ENGINE – ENGINE HP TURBINE ROTOR AND STATOR ASSEMBLY – REMOVAL OF THE ORIFICE PLATES  
AND RELATED HARDWARE FROM THE HPT CASE ASSEMBLY – CATEGORY CODE 3 – MOD.ENG-72-0058

V2500-ENG-72-0058

Removal of Orifice Plate  
Fig.1 (Sheet 1 of 2)

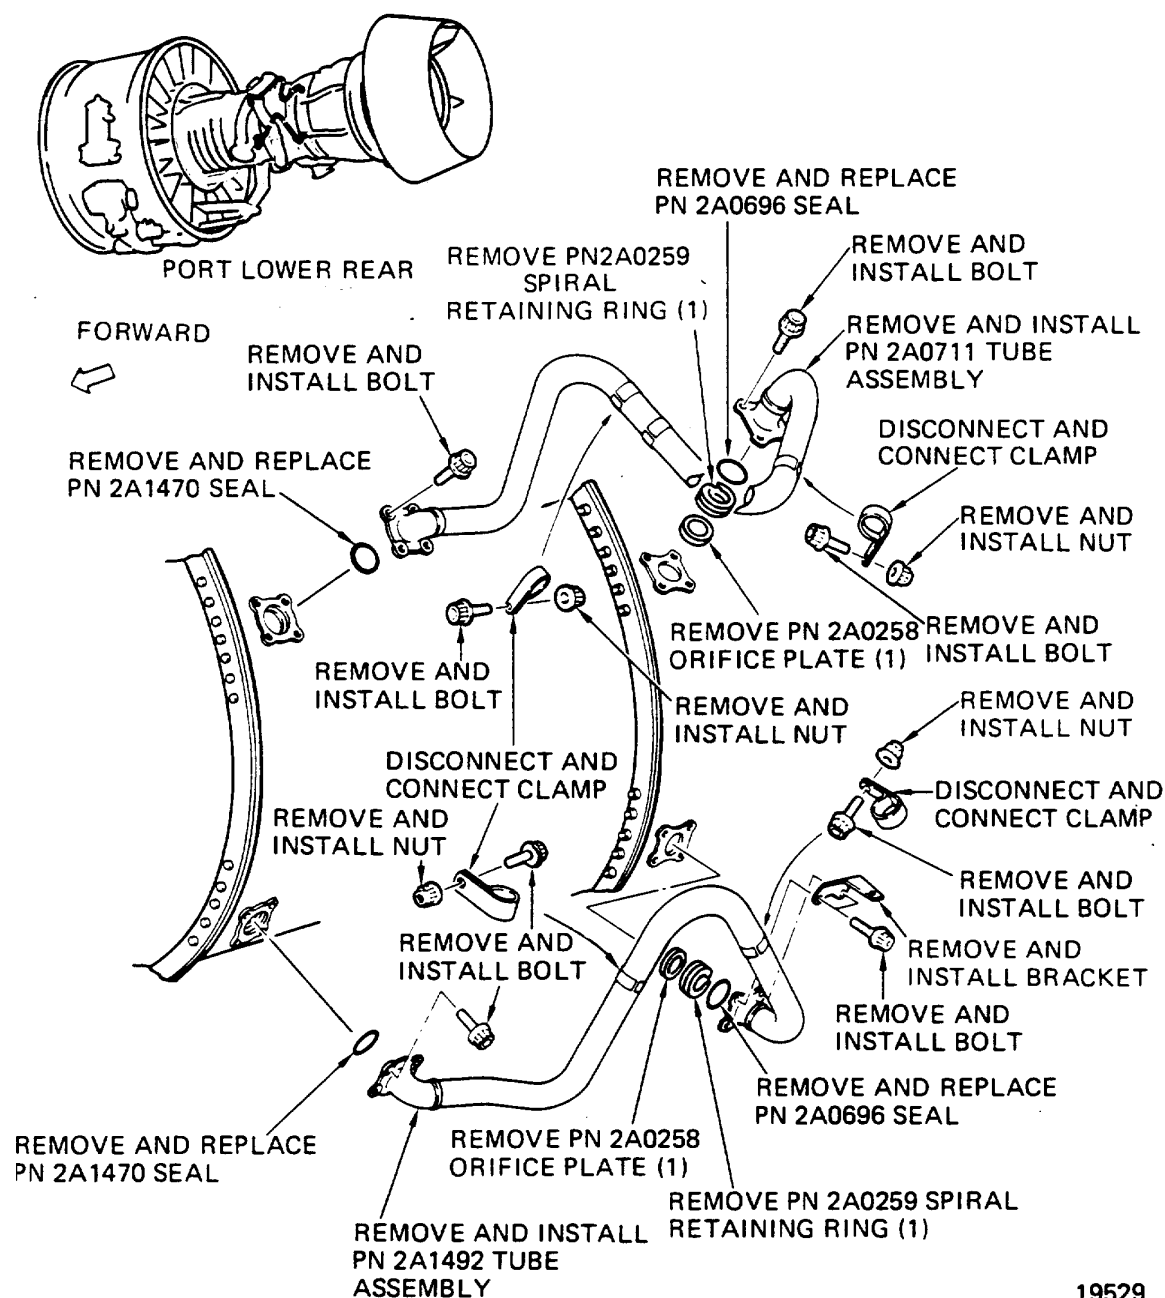
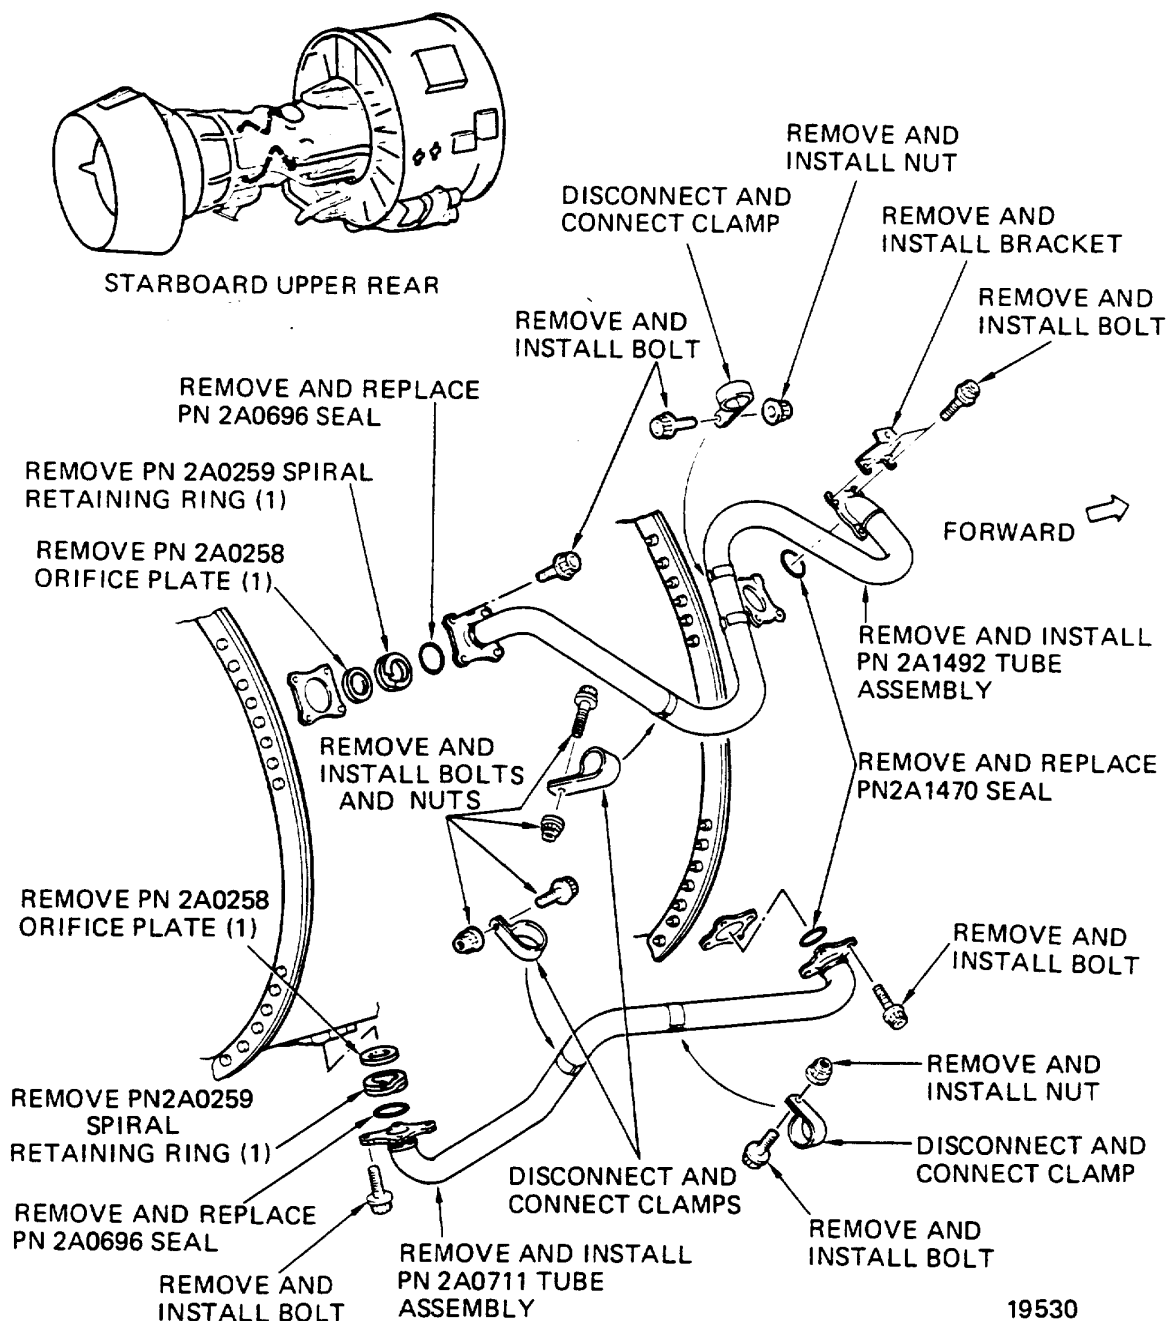
- (1) Deterioration of Turbine, before the usual time, is decreased by removal of the orifice plates at both ends of the Turbine Cooling Air Tubes.

- (1) Remove the Turbine Cooling Air Tubes by the approved procedure in Reference (1) Chapter/Section 72-00-50, Removal-01. Refer to Figure 1.
- (2) Remove the Spiral Retaining Rings and the Orifice Plates from the Turbine Case Assembly as follows:
  - (a) Remove the 2A0259 Spiral Retaining Ring from the groove in the Case Boss (four locations). Refer to Figure 1.
  - (b) Remove the 2A0258 Orifice Plate from the Case Boss (four locations). Refer to Figure 1.
- (3) Install the Turbine Cooling Air Tubes by the approved procedure in Reference (1), Chapter/Section 72-00-50, Installation-07. Refer to Figure 1.
- (4) Make sure that the New Part Number 2A1600A is shown on the Turbine Exhaust Case Assembly.
